Planning & Development Division
Planning & Economic Development Department

File Number	PLVAR-2508-0010	Contact	Jason Mozol, jmozol@duluthmn.gov	
Type	Variance from Shoreland Setbacks	Planning Commission Date		December 9, 2025
Deadline for Action	Application Date	November 4, 2025	60 Days	January 3, 2026
	Date Extension Letter Mailed	November 26, 2025	120 Days	March 4, 2026
Location of Subject		Corner of E Palm St and Blackman Ave		
Applicant	City of Duluth, Engineering	Contact	Nathan Bruno and Ryan Granlund	
Agent	LHB	Contact	Heidi Bringman	
Legal Description		010-2710-05980, 010-0360-00571, 010-2710-06001		
Site Visit Date		June 16, 2025	Sign Notice Date	
			November 25, 2025	
Neighbor Letter Date		November 13, 2025	Number of Letters Sent	
			29

Variance to Shoreland Setbacks
Special Use Permit
Palm Street Pond

PALM STREET PERMANENT STORMWATER MANAGEMENT SYSTEM IMPROVEMENTS

LANDSCAPE PLANS
 SHEET NO. LA02 OF 3 SHEETS

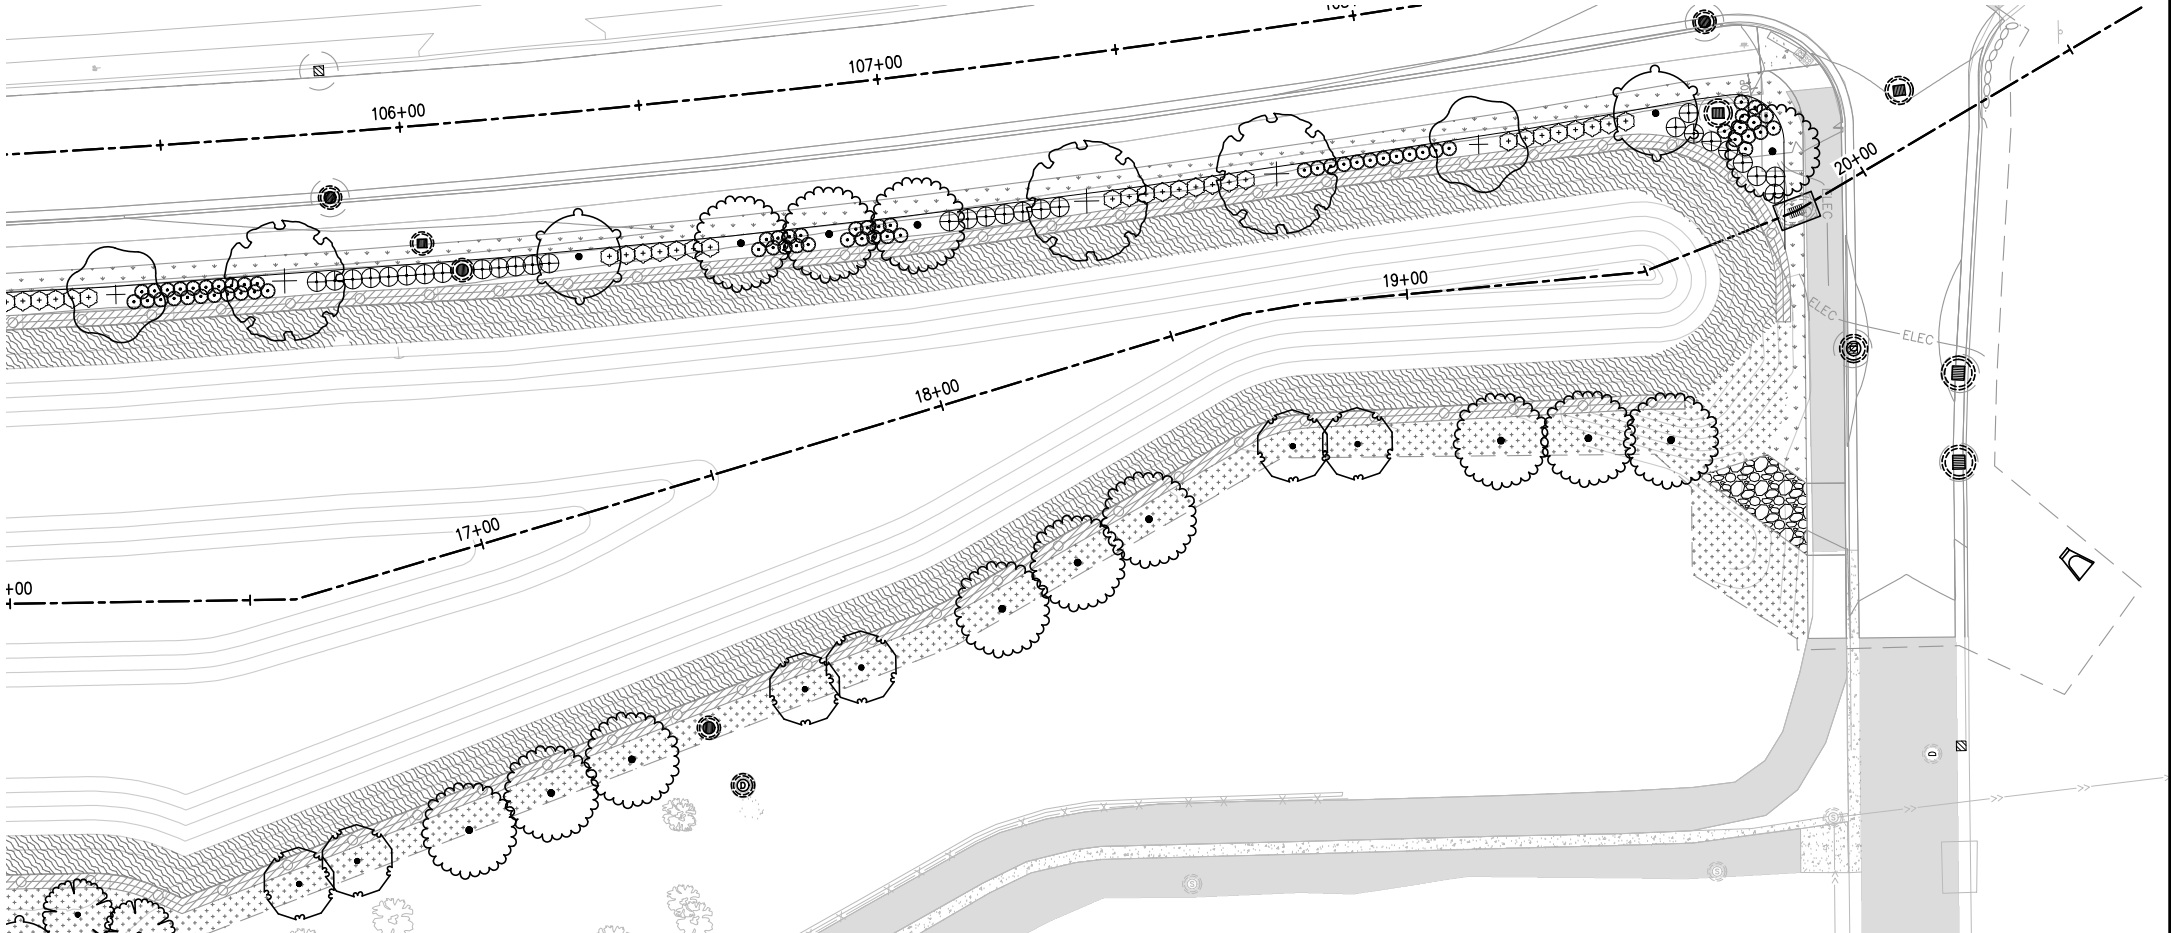
- 8) *Variance Criteria #6 (will not impair intent of this Chapter or alter the essential character of the locality)*. This project will alter the appearance of the site from a stormwater basin that is primarily vegetated due to deferred maintenance, to a basin that is largely hardscaped and includes constructed sheet pile structures. The essential character of the area will not be severely altered since the use of the property is not changing. The change in appearance of the stormwater basin is mitigated by vegetative plantings discussed in item 9 below and shown in the attached landscaping plan.

- 9) *Standards for variances in shorelands (does not compromise intent of shoreland regulations and mitigates impacts)*. The basin itself will have direct benefits to the watershed by mitigating downstream flooding and erosion and treating stormwater for pollutants and sedimentation. Reconstruction will also remediate contaminated soils currently in the basin and establish a design that will be easier to remove pollutants in the future. The applicant is also proposing to plant trees and shrubs around the perimeter of the basin and revegetate areas within the basin with plugs and seed mixes of native plants.
